**Development Review Board
Panel B Meeting
April 27, 2020
6:30 pm**

Exhibit A1
Staff Report
Wilsonville Planning Division
Nicoli Pacific Industrial Building and Storage Yard

Hearing Date:	April 27, 2020
Date of Report:	April 20, 2020
Application Nos.:	DB20-0002 Stage I Master Plan Modification DB20-0003 Stage II Final Plan DB20-0004 Site Design Review DB20-0005 Class III Sign Review DB20-0006 Type C Tree Removal Plan
Request/Summary:	The requests before the Development Review Board include a Stage I Master Plan Modification for a 3-phase industrial development, Stage II Final Plan, Site Design Review, Class III Sign Review, and Type C Tree Removal Plan for Phase 1, which is a 13,200-square-foot industrial building and 52,700-square-foot storage yard.
Location:	South of SW Boeckman Road between SW Boberg Road and SW Boones Ferry Road/Interstate 5. The property is specifically known as Tax Lots 300 and 500, Section 14A, Township 3 South, Range 1 West, Willamette Meridian, City of Wilsonville, Clackamas County, Oregon
Owner:	Nicoli Pacific, LLC (Contact: David Nicoli)

Modified Stage I Master Plan

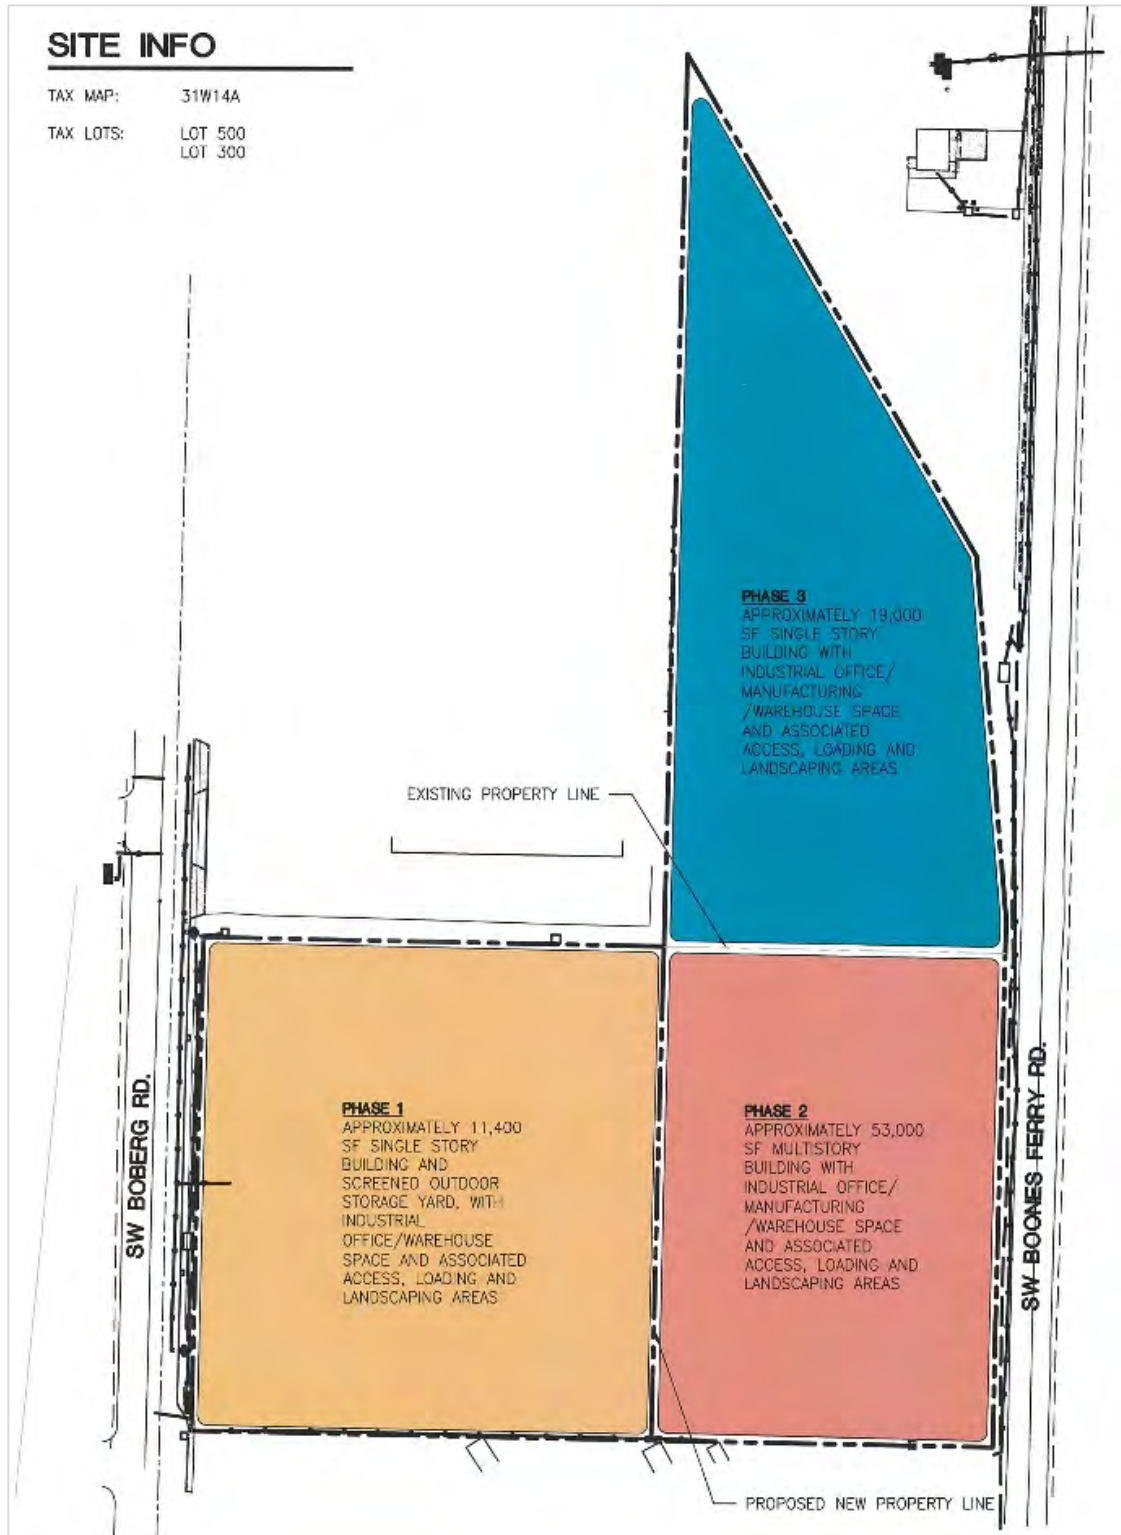
The current request for Stage I Master Plan Modification changes both the order of development and anticipated building size for Phases 1 and 2. Per the applicant’s narrative, this is due to unanticipated site grading limitations and economic obstacles associated with the development as initially proposed. The table below compares the approved Stage I Master Plan and requested modification. In addition, the diagram that follows below illustrates the modified Master Plan.

The current request for Stage I Master Plan Modification retains the overall intent to develop the property in three phases, but changes the order of development, anticipated building size for Phases 1 and 2, and total square footage of buildings at full build-out. Per the applicant's narrative, this is due to unanticipated site grading limitations and economic obstacles associated with the development as initially proposed. The phasing schedule and Phase 3 remain the same, with construction anticipated in 2020 (Phase 1), 2024 (Phase 2), and 2029 (Phase 3).

Building Elevations: West (right) and North (below)

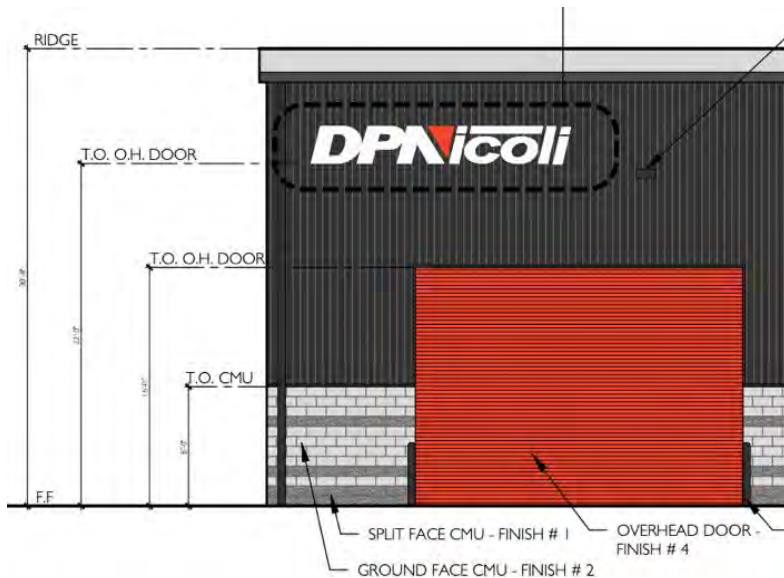
The proposed project includes a new engineered metal building on the south side of the Phase 1 site with a secure, screened outdoor storage area on the north side. As described in the applicant's narrative, the layout and design provide variation in materials complementary to the commercial industrial context of the location while offsetting the simplistic geometry of a standard metal building. Contrasting color selection of black, red, and gray, and varying texture of vertical metal siding and ground- and split-face CMU block that wraps the base of the building add interest and color, giving the building a modern aesthetic appeal. Landscaping enhances and improves connectivity to neighboring properties while contributing to the development's visual environment providing buffering and screening to the residential area to the south.

The subject property has frontage on SW Boberg Road and building signs are proposed on the north and west sign-eligible elevations, as shown in the above elevations. A sign detail is included below. No signs are proposed on the south and east sides of the building. Proposed signs are appropriately located on the building and are within the sign area allowed for each elevation. No freestanding signs are proposed along SW Boberg Road. The diagram below shows the proposed building-mounted sign on the north elevation.
